6. Nature conservation

6.1 Summary of comments

FIGURE 6.1

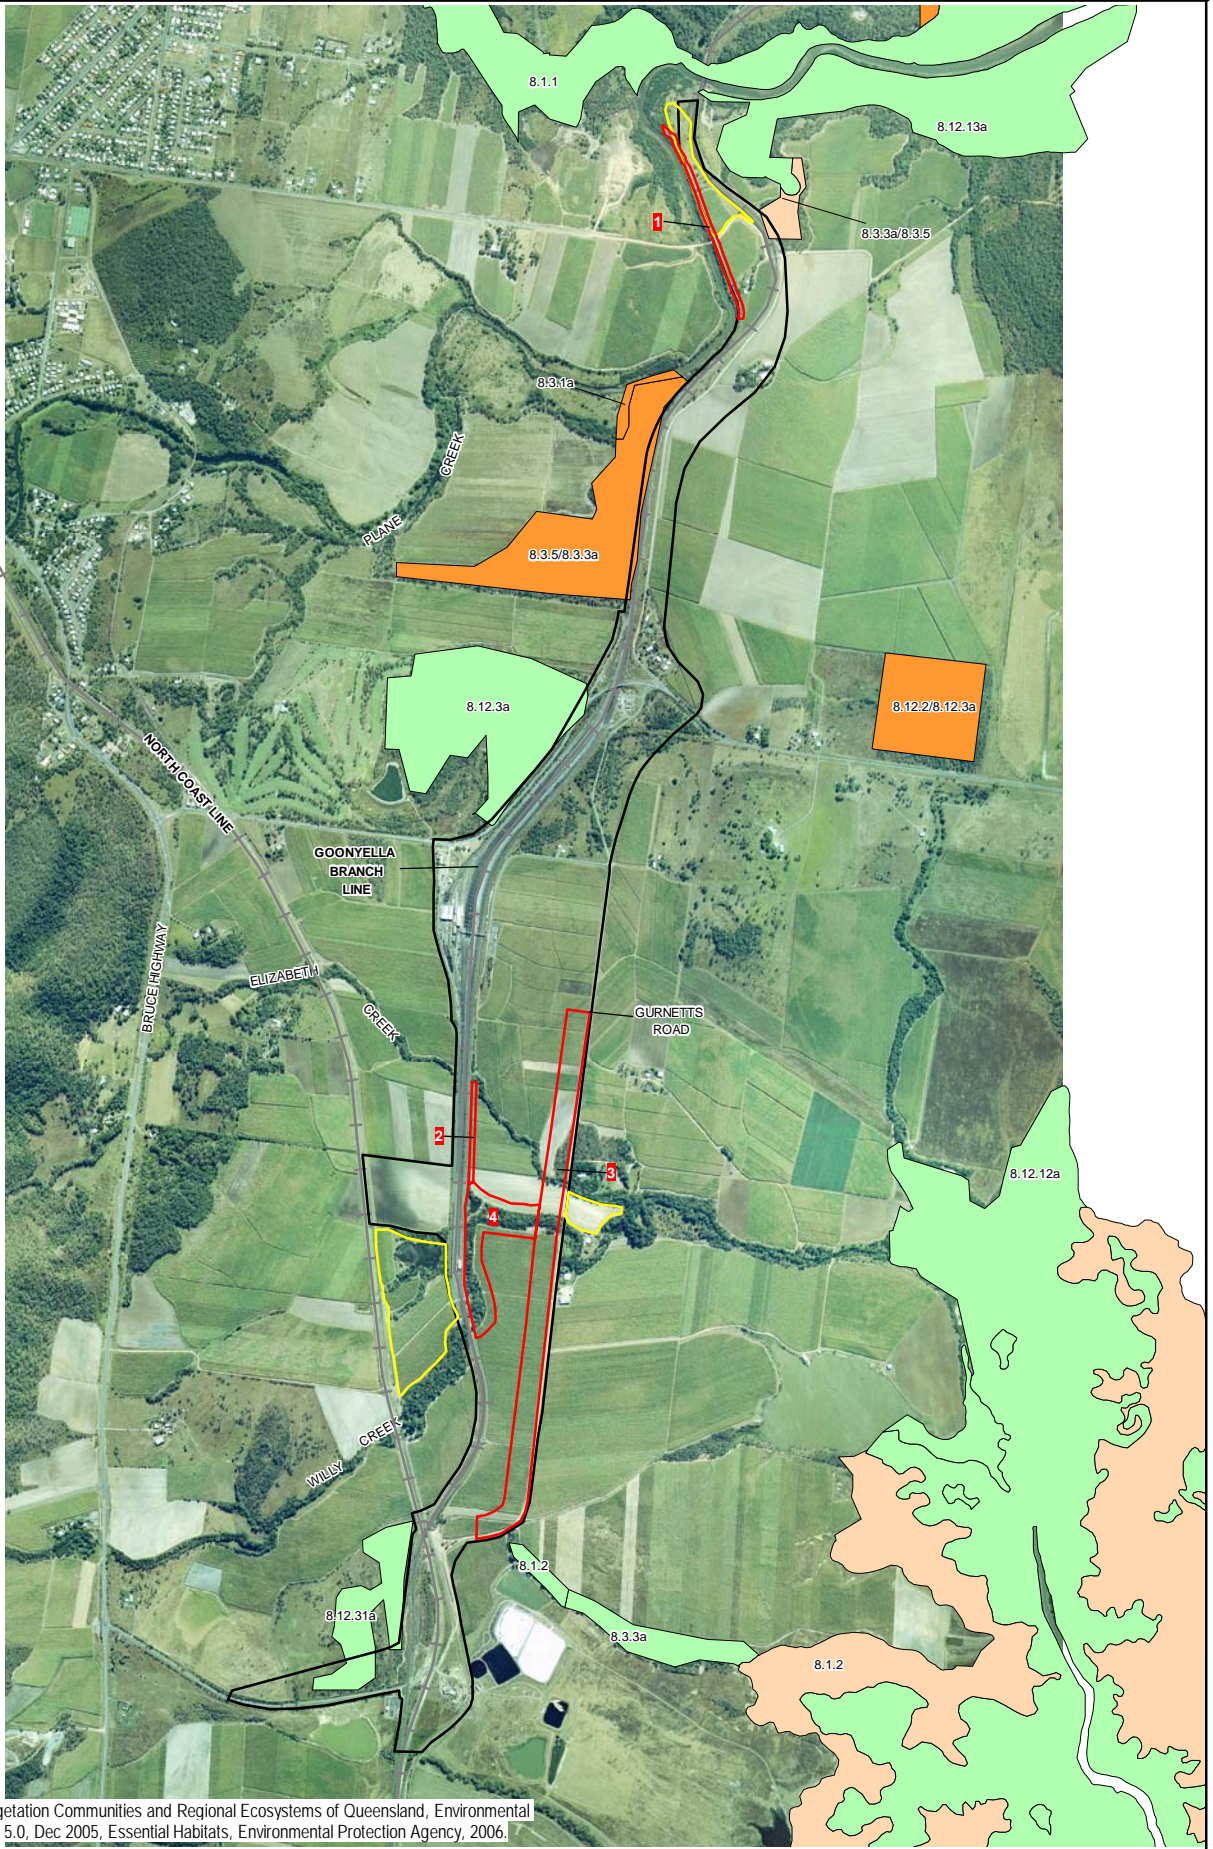
- Commitments are required to minimise vegetation clearing within the project area.
- Commitment to maintain Plane Creek riparian buffer zone of 20 m.
- Clearing of Regional Ecosystems (REs).
- Additional information to be provided in relation to the removal of marine plants in the form of an Application for the Disturbance/Removal of Marine Vegetation.
- Revegetation plans required.

- A Vegetation Rehabilitation Strategy for QR owned land within and adjacent to the project area will be produced and implemented. The strategy will outline rehabilitation management strategies for specific locations throughout the project area. As shown in Figure 6.1, specific areas targeted for rehabilitation will be as follows:

- *Location 1: A vegetation buffer adjacent to Plane Creek.* A 20 m wide vegetation buffer on QR owned land will be planted adjacent to the Plane Creek riparian vegetation to increase the integrity of the existing riparian zone. This buffer zone will increase connectivity between creek systems and provide some protection from sediment loads and nutrients that may result from construction activities. It is anticipated that the buffer will also minimise adverse impacts on the Plane Creek coastal resource and its values.

- *Location 2: A high flow bypass channel between Elizabeth and Willy Creeks.* As recommended in the Department of Primary Industries and Fisheries (DPIF) comments on the Jilalan EIS dated 26 October 2007, a high flow bypass channel incorporating two to three refuge pools between Elizabeth and Willy Creeks will be incorporated into the final design. These pools will be 50 m long, 15-20 m wide and at least 3 m deep. The riparian zone around the artificial channel will be vegetated with local native vegetation to aid in mimicking a natural system (ie native species identified in the existing riparian zone of Elizabeth and Willy Creeks).

- *Location 3: A vegetation buffer along Gurnetts Road.* A vegetation buffer to reduce the visual impact of the rail upgrade on residential dwellings directly adjacent the project area will be planted along the western side of Gurnetts Road.

- *Location 4: An expansion of the existing riparian zone along Willy Creek.* Where practicable the riparian zone on either side of Willy Creek will be expanded to a minimum width of 20 m to increase overall connectivity, habitat value and bank stability. The rehabilitation component of this area will be incorporated with the overall rail design features which include utilising bridged structures over the creek itself and providing suitable instream fisheries habitat which may be lost due to changes in hydrological regimes resulting from construction activities. Measures such as refuge pools and rock ridges will be encouraged for implementation in downstream environs of Willy Creek where practicable.

- *Potential expansion to vegetation rehabilitation area.* Where practicable and where QR land within and directly adjacent to the project area is not intended to be returned to sugar cane cultivation there is the potential to further expand revegetation areas. This will assist in the protection of and increase in the integrity of existing wetland and riparian vegetation and improve overall connectivity between these areas.
